<u>#</u>	<u>Description</u>
REM-I-361	Periodic Incore Detector Leakage Measurements
REM-I-371	FHE Site Caution Instructions
REM-I-372	Nuclear Spare Parts Service
REM-I-391	Fuel Transfer Basket Load Distribution
REM-I-392	Fuel Transfer System Cable Takeup Reels
REM-I-393	Fuel Handling Bridge Hydraulic Hose Deterioration

Babcock & Wilcox

REM-I-361

Subject: Periodic Incore Detector Leakage Measurements

RC Temperature - °F
FIGURE 1.0-G5.2

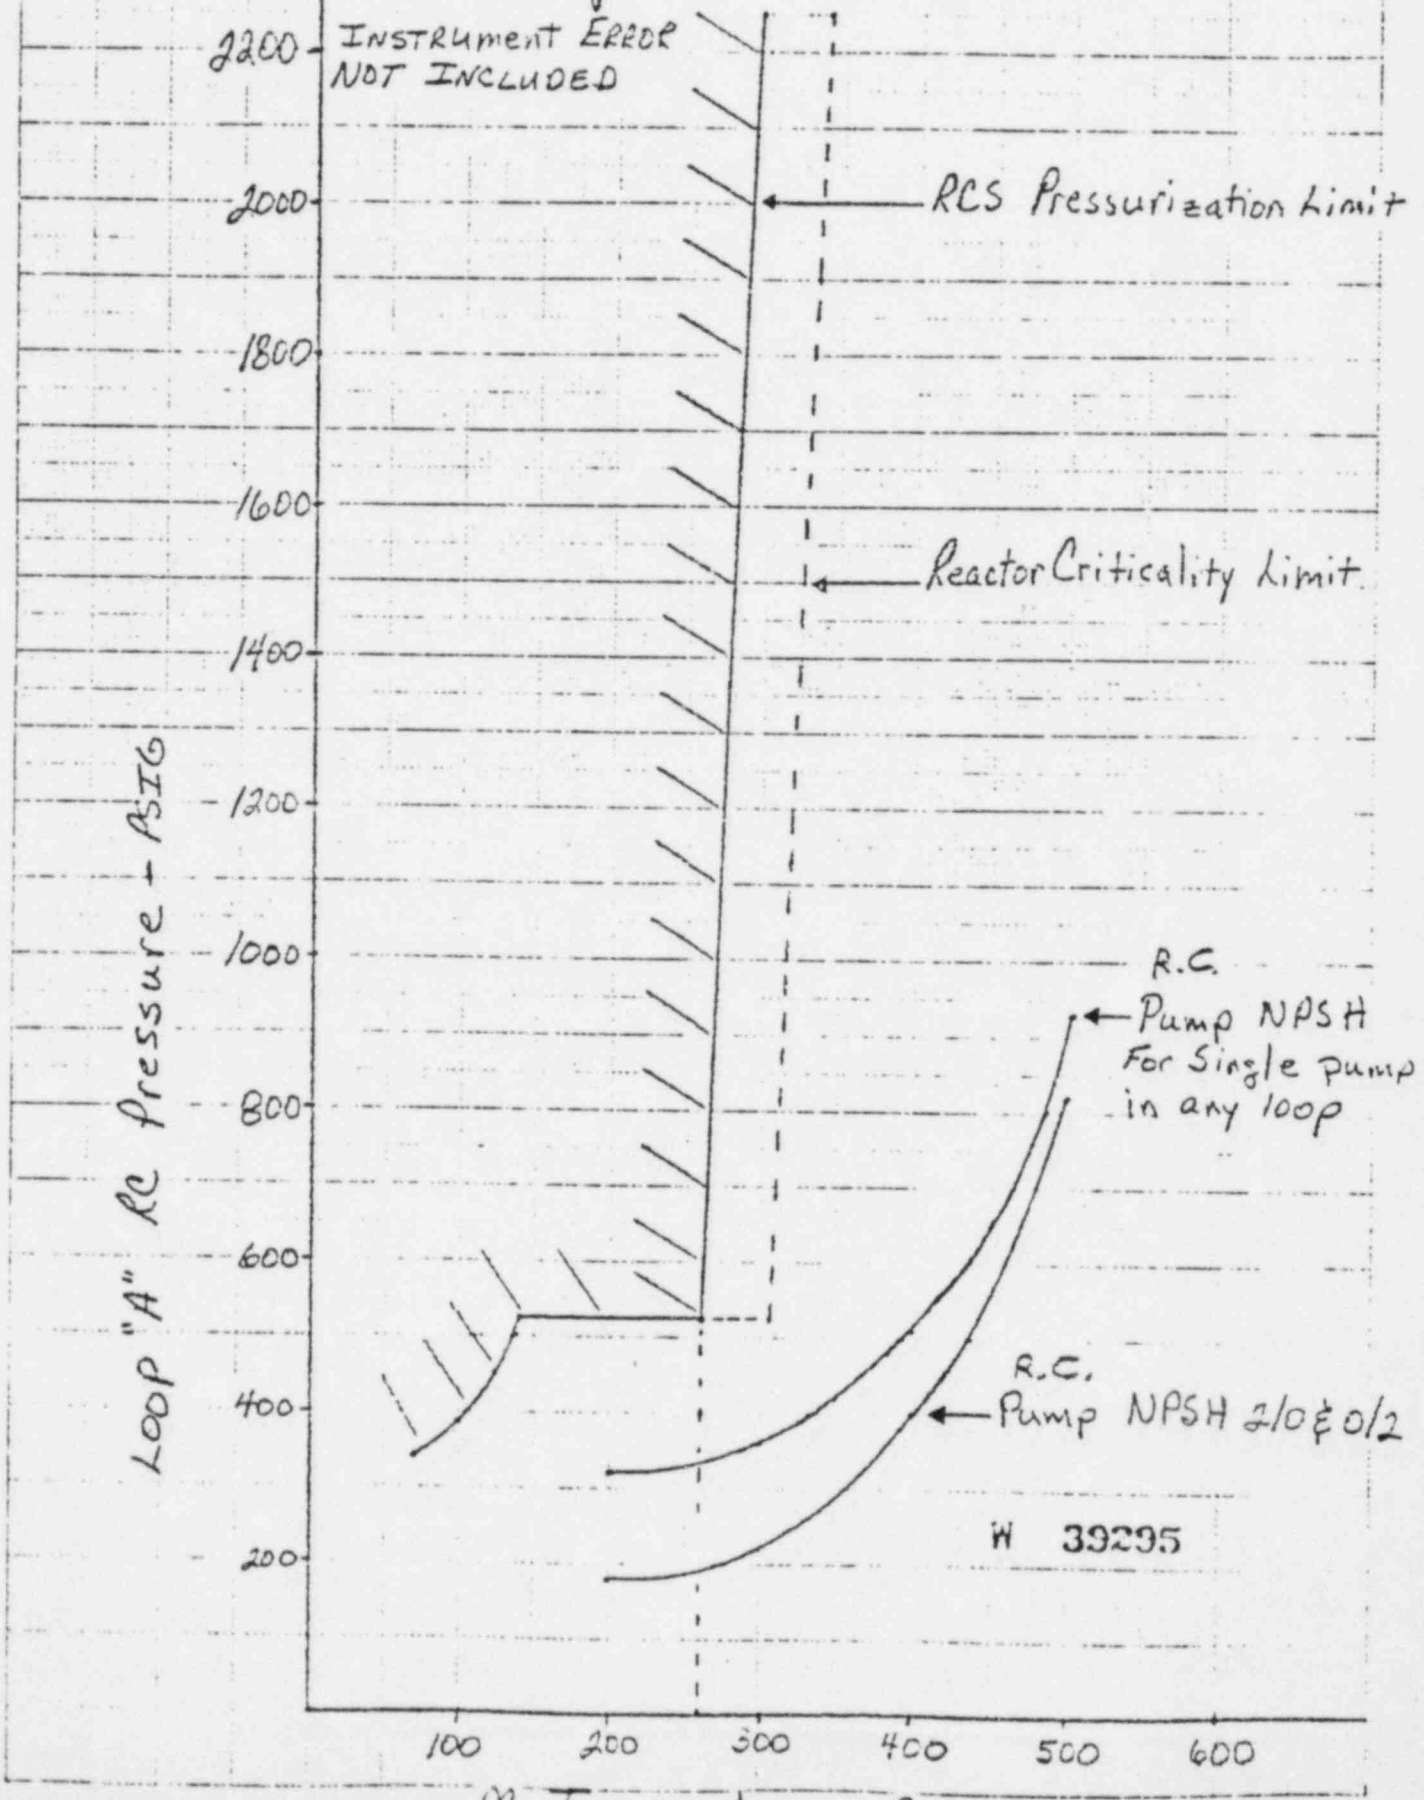
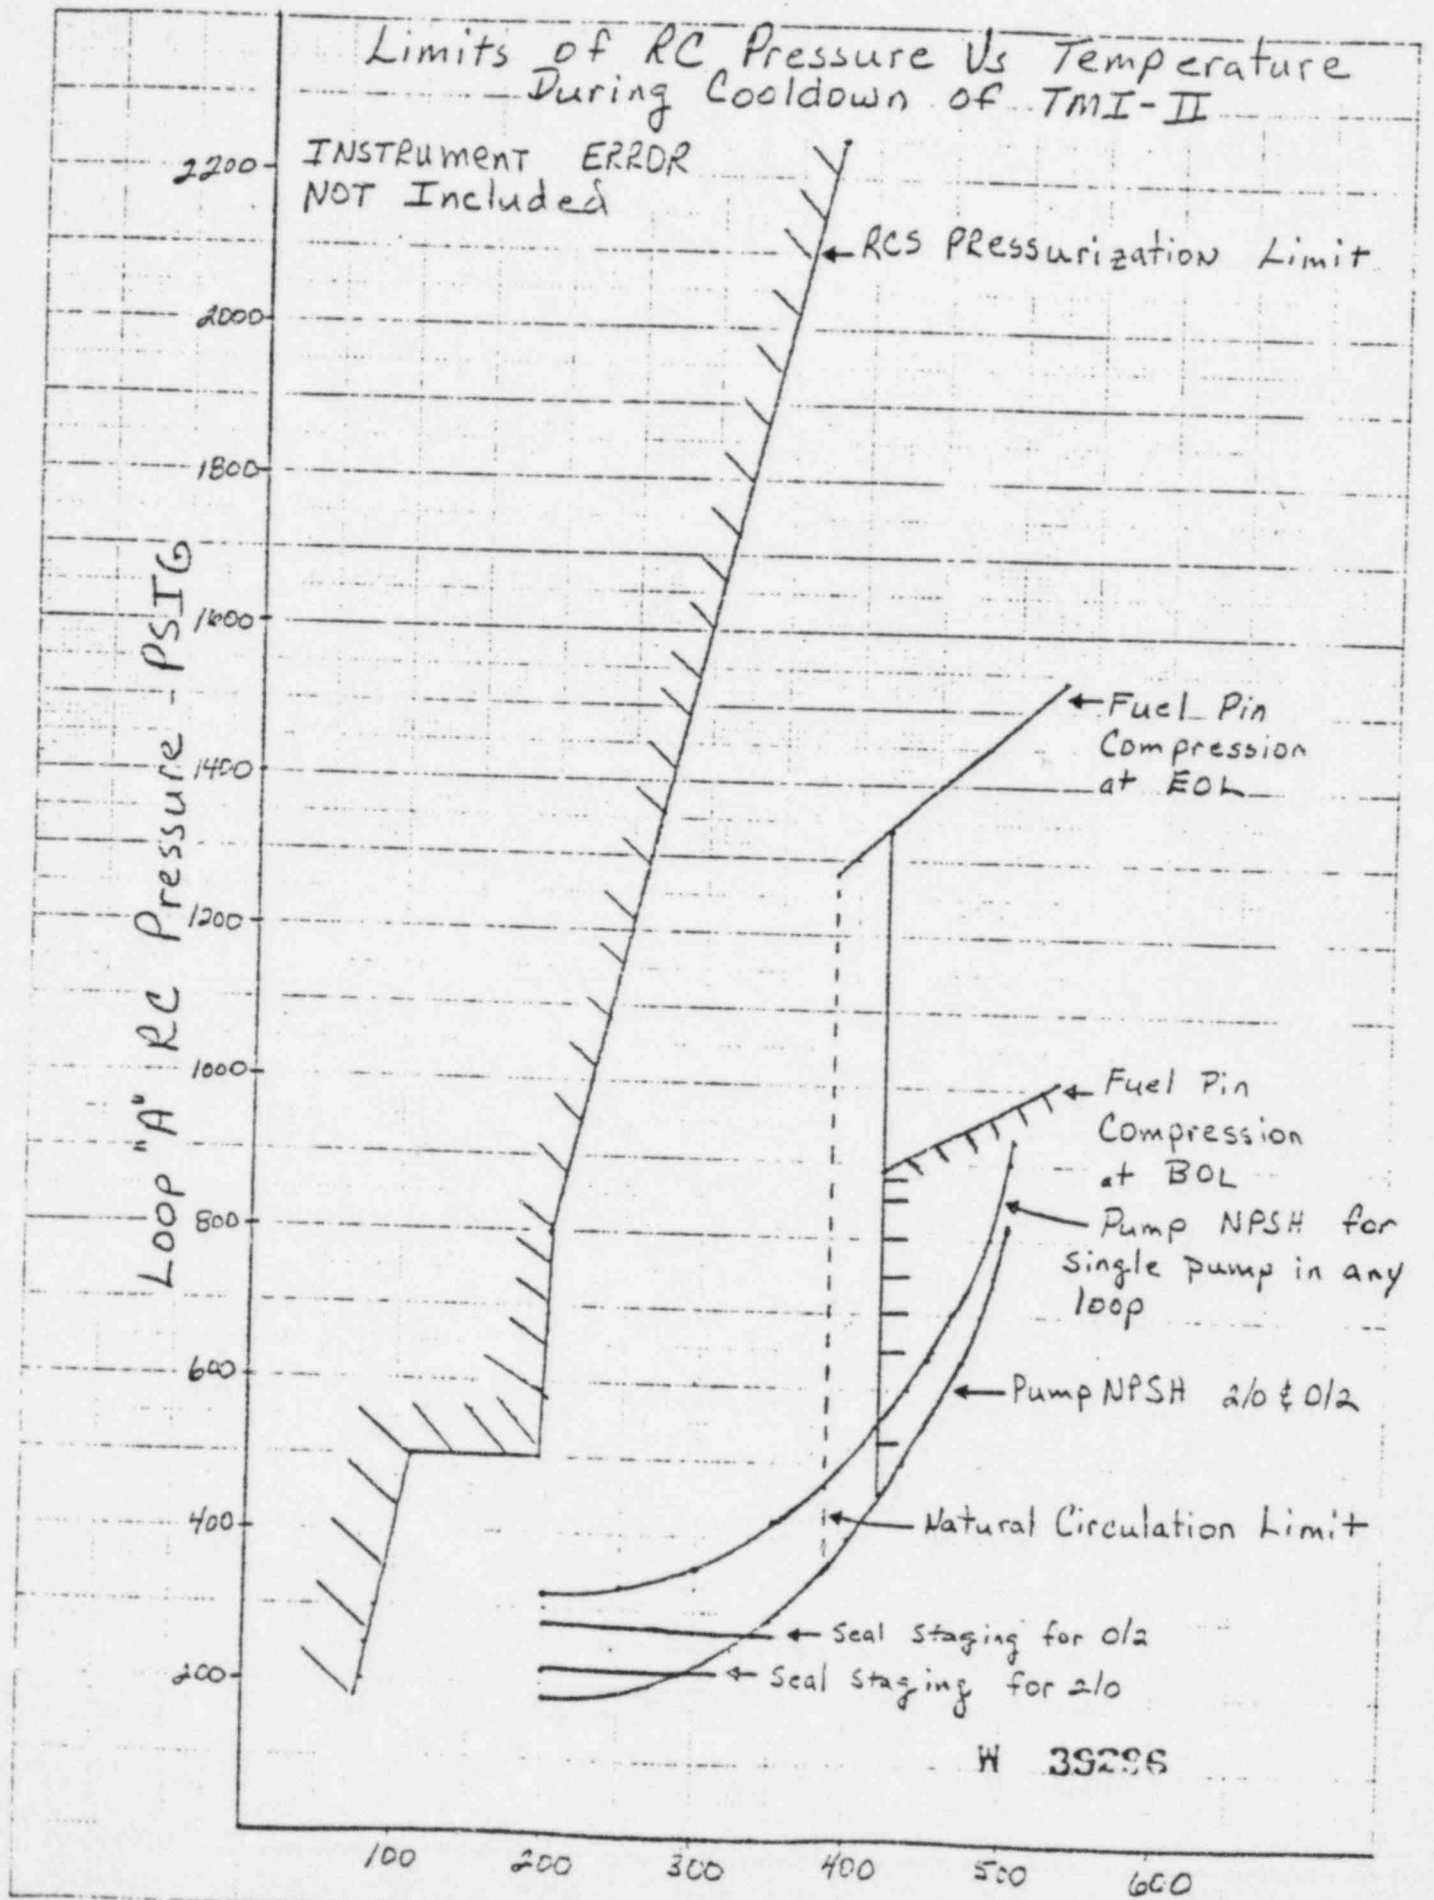
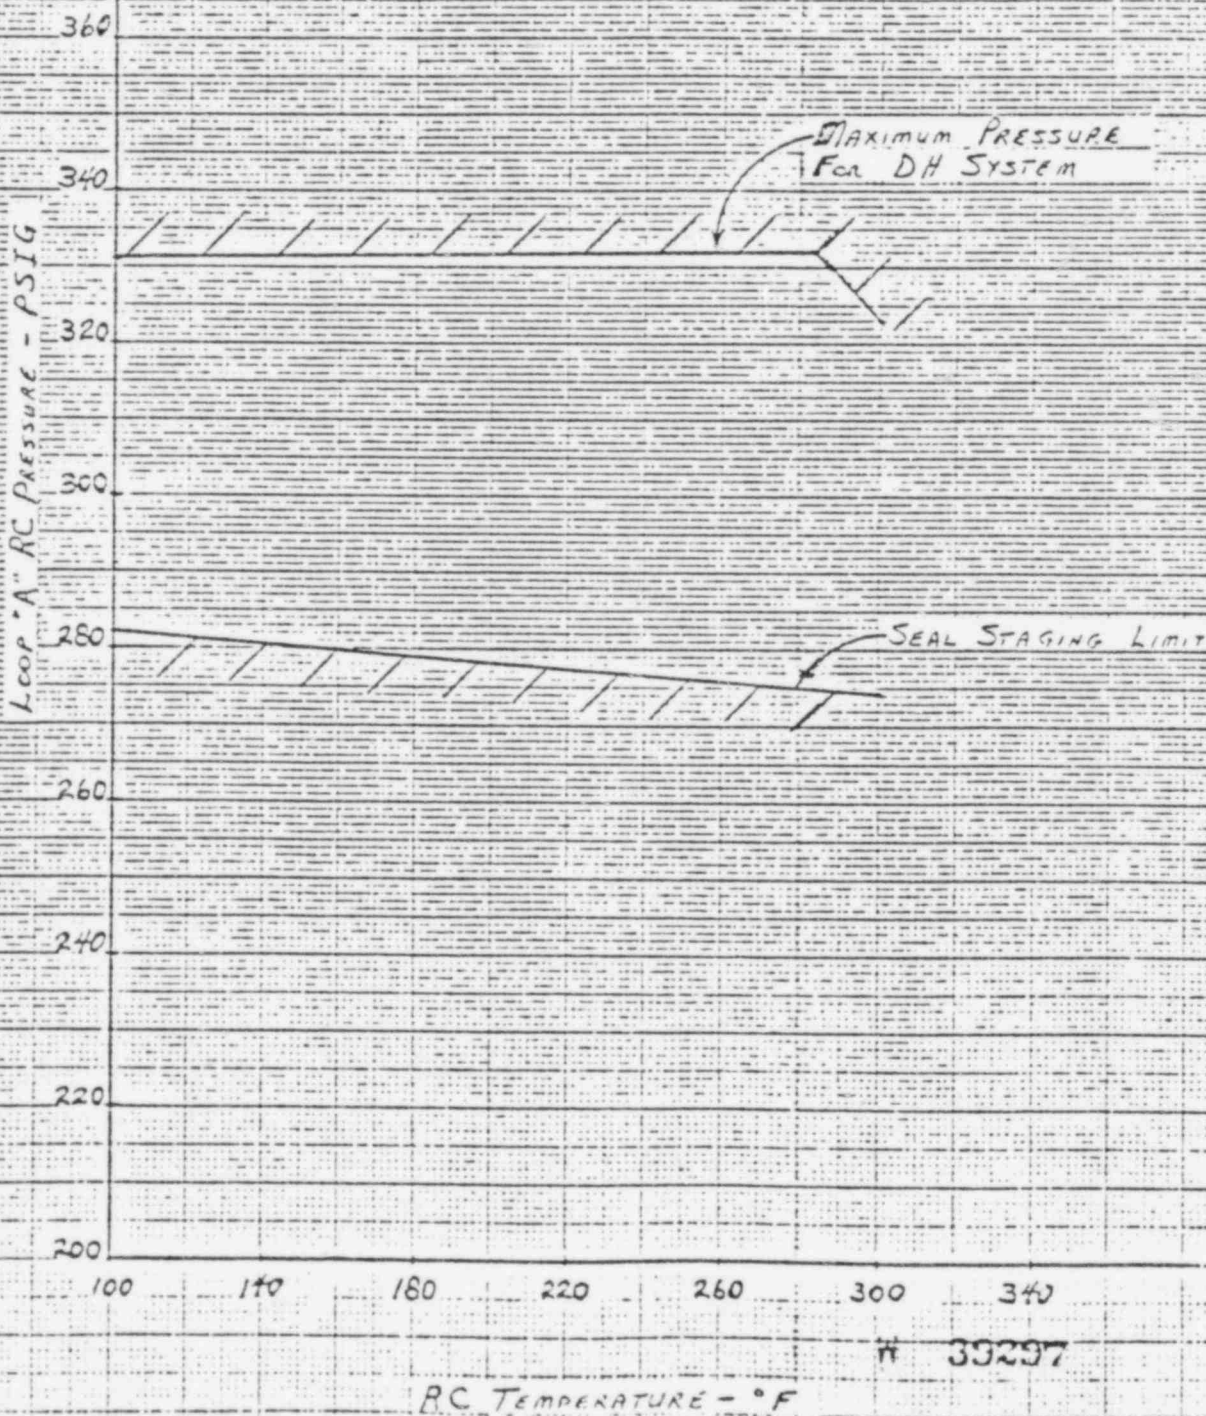
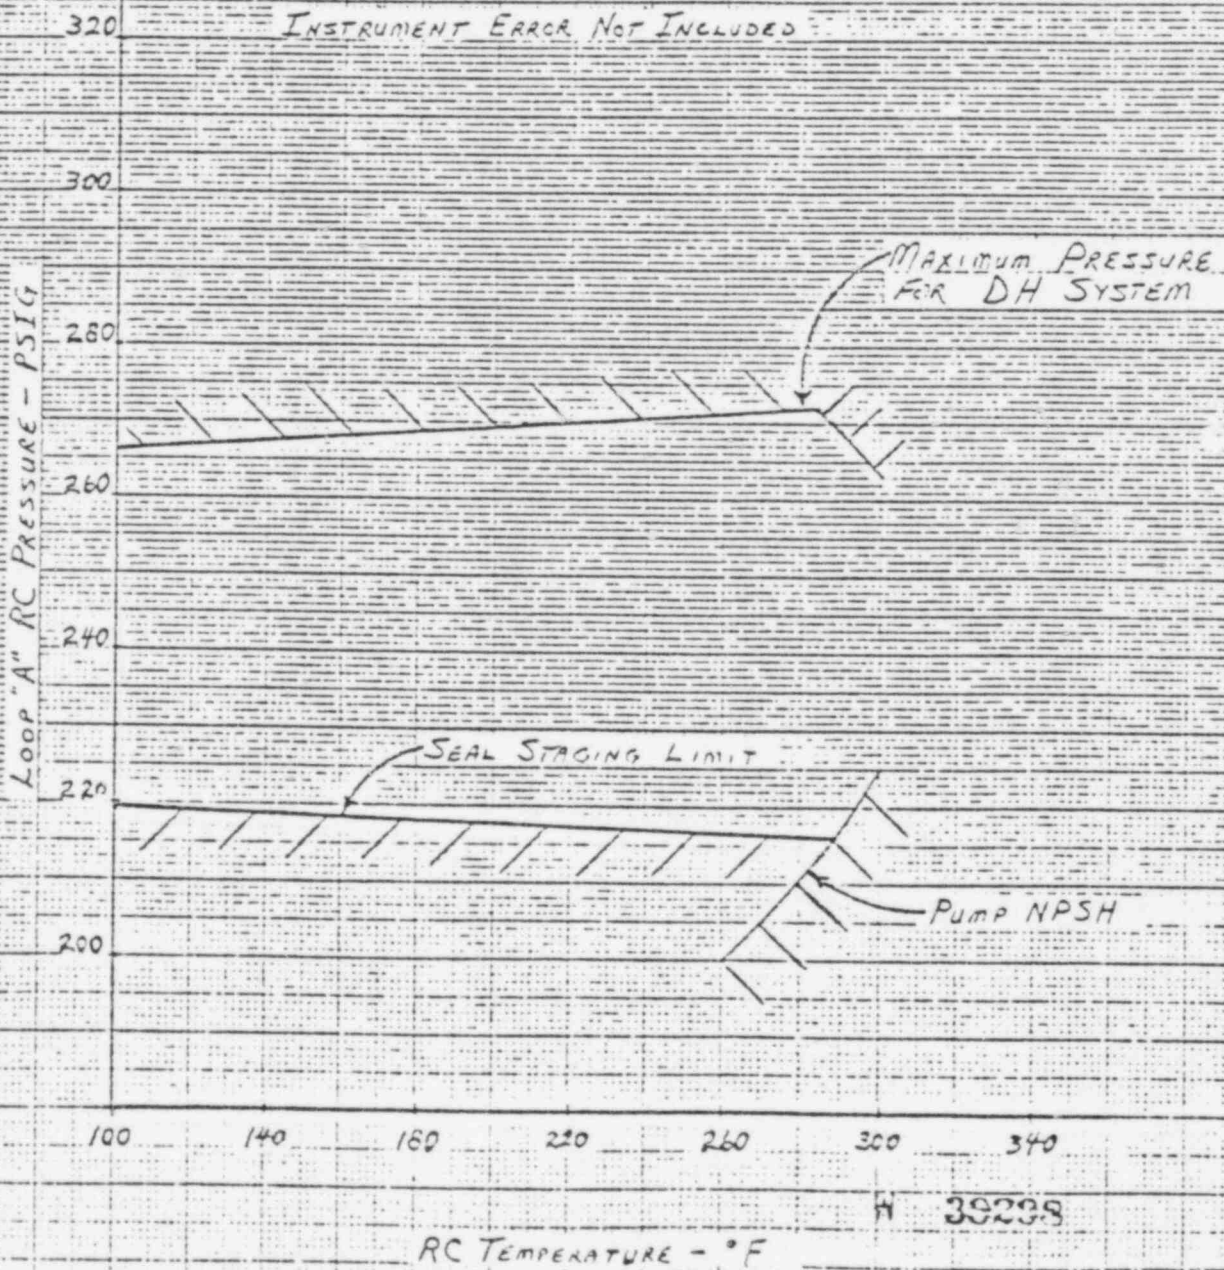
1. Replace Figures 1.0-05.1; 1.0-05.2; 1.0-05.3; and 1.0-05.4 with the new figures attached to this letter.

The new figures, 1.0-05.1 through 1.0-05.4, include the information contained in the curves (Figure 1-3) attached to the SOM-II-106 letter dated 31 January 1978. The information in SOM-II-106 is still valid.
